# **2004 - 2009 Cadillac XLR: Service Bulletin: #01-07-30-032E: Transmission Oil Leaking From Transmission Vent**

## **#01-07-30-032E: Transmission Oil Leaking From Transmission Vent (Replace Transmission Case Cover (Channel Plate) Gasket) - (Sep 29, 2008)**

**Models:** 1997-2009 GM  
Passenger Cars and  
Light Duty Trucks  
(including Saturn)

with Hydra-Matic  
4T65-E Automatic  
Transmission (RPOs  
MN3, MN7, M15, M76)

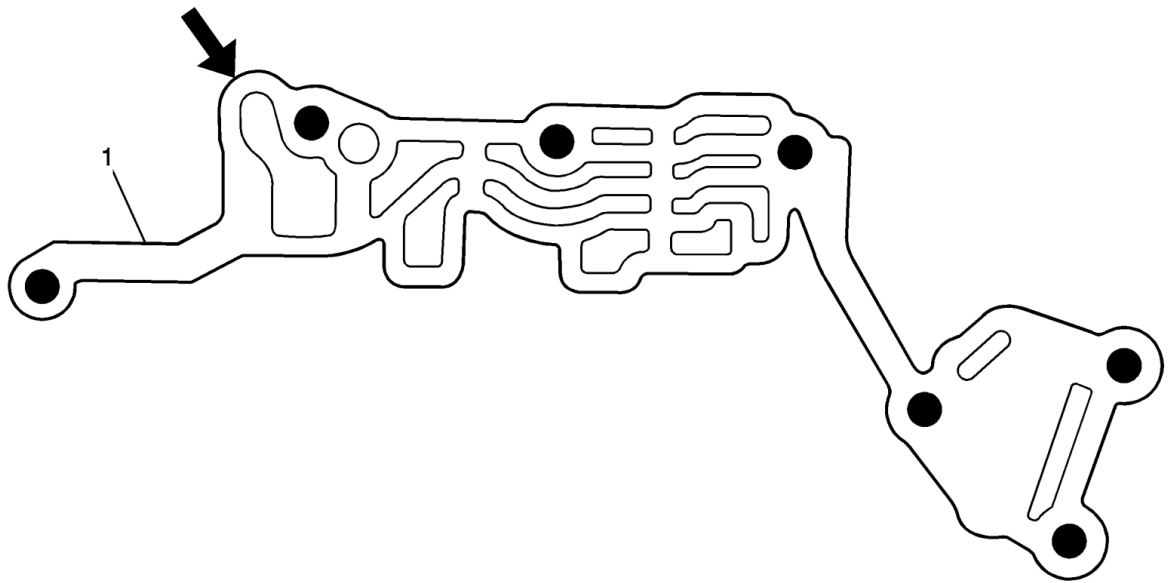
This condition may be caused by an improperly torqued channel plate gasket.

Visual inspection of the upper gasket (1) will reveal damage at the referenced area.

To correct this condition, replace the case cover (channel plate) gaskets (429 and 430). Refer to Unit Repair publication in SI of the appropriate vehicle being serviced.
